VSR-TSB-034

Vehicle Safety Recall - Technical Service Bulletin

Attention: Oshkosh Product Owner
Subject: Front Axle U-Bolts
Models Affected: Oshkosh S-Series Front Discharge Mixer
Model Year: 2019-2022 (VIN 788727 - 814106)
Date: February 2022

Figure 1

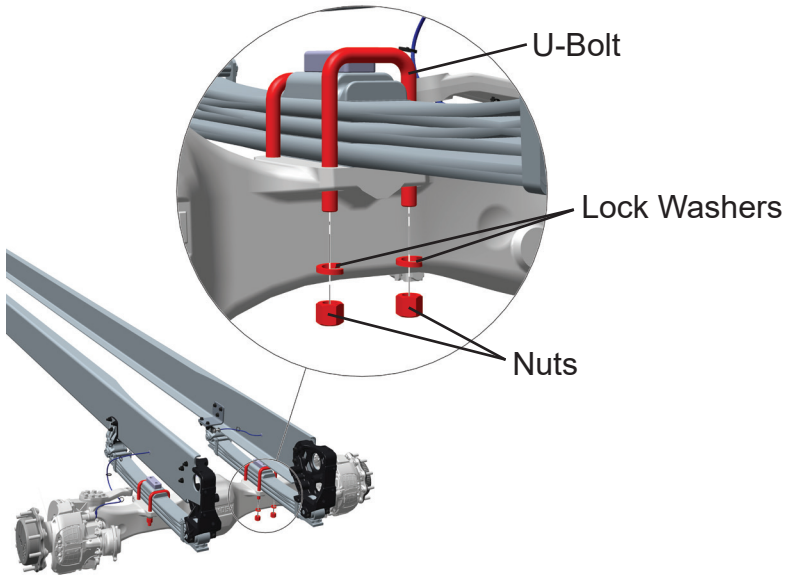
- Loosen and remove nuts and lock washers from one U-bolt, see Figure 1. Nuts and lock washers will not be reused.
- Remove U-bolt from axle and spring assembly, see Figure 1. U-bolt will not be reused.

Figure 2

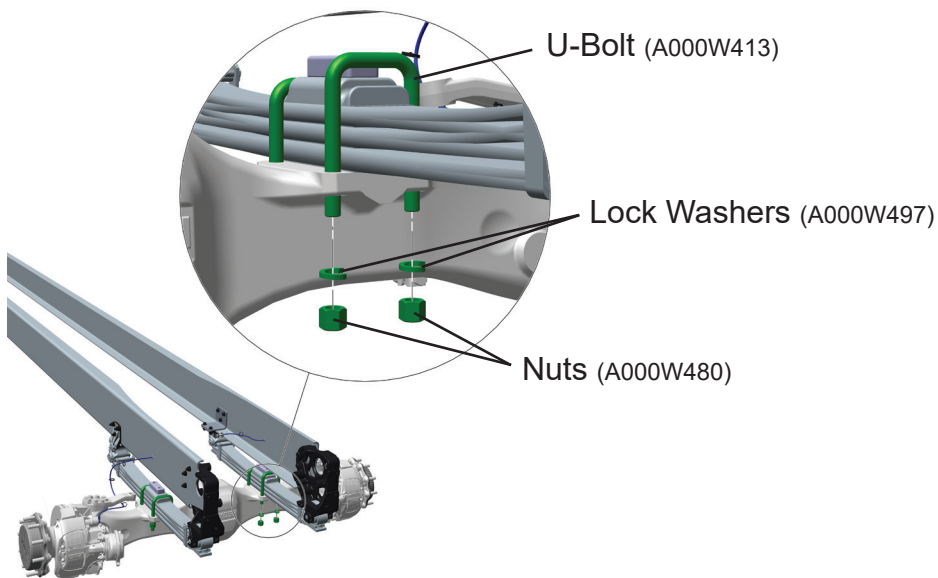
- Install new U-bolt (A000W413) over spring assembly and into axle flange, see Figure 2.
- Install new lock washers (A000W497) and nuts (A000W480) on U-bolt, see Figure 2. Snug nuts on U-bolt, do not final tighten at this time.

Figure 3

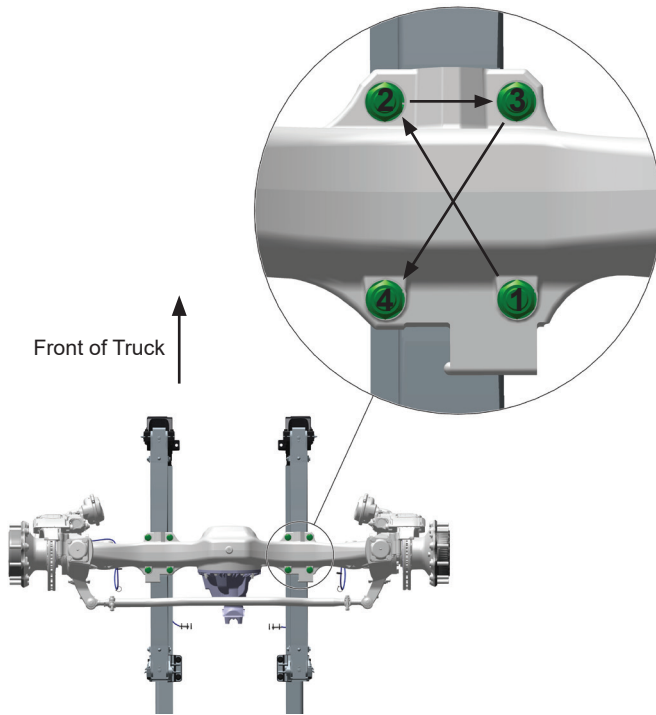
9. Tighten left and right U-bolt groups evenly using 200 ft. lbs. increments to 600 ft. lbs. Follow torque sequence in Figure 3.
